Subject	► Change of Field
For Models	► 1911B, 1912B
Country	► All countries
Description	► See below.

For 1911B for European countries, China, Australia, New Zealand, Papua New Guinea

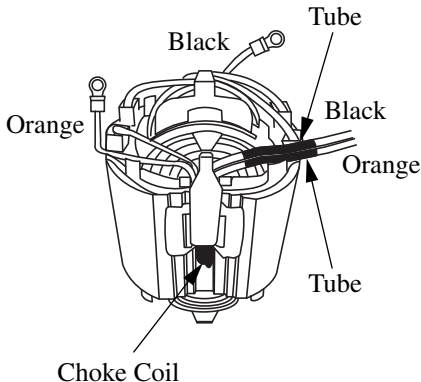
Field without Choke Coil has been replaced by Field with Choke Coil.

► Current	► New
 <p>Refer to wiring section on page 2 and 3 for color of Lead Wires.</p>	 <p>Choke Coil</p>

For 1911B for China, Australia, New Zealand, Papua New Guinea, European countries

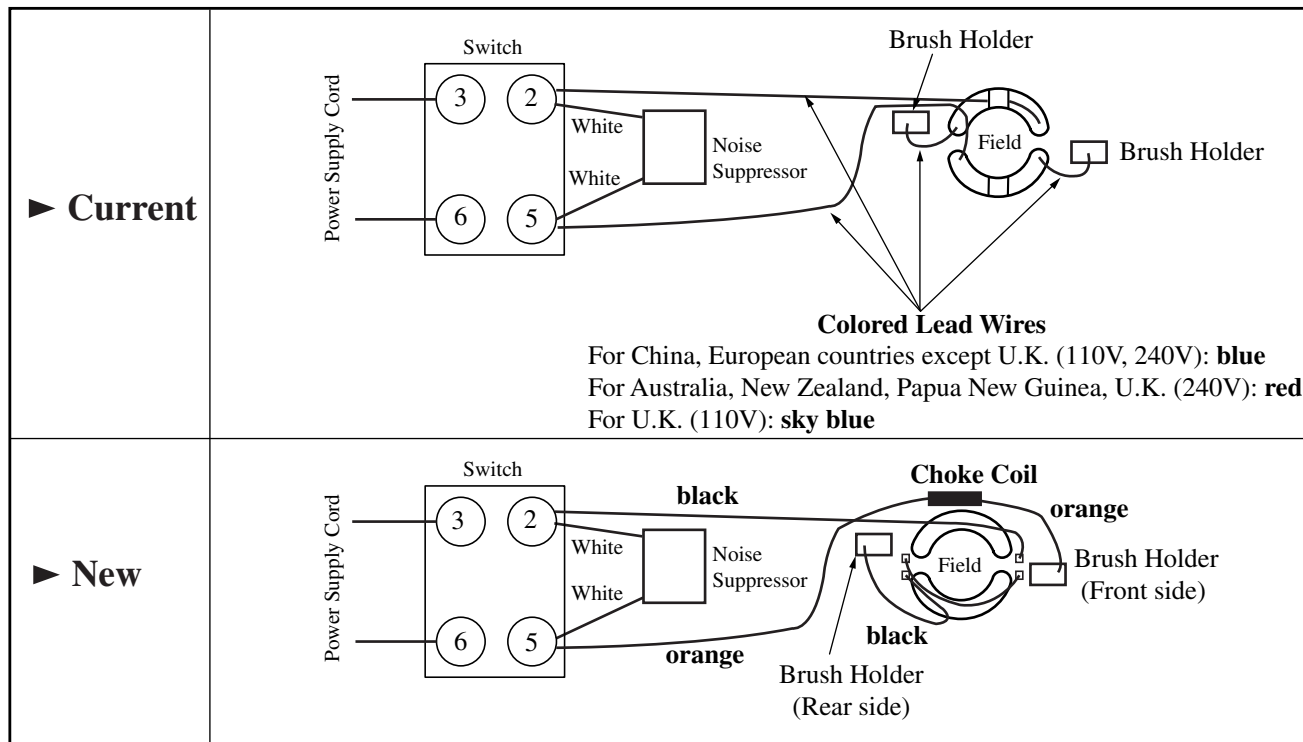
Wiring has been changed as shown below.
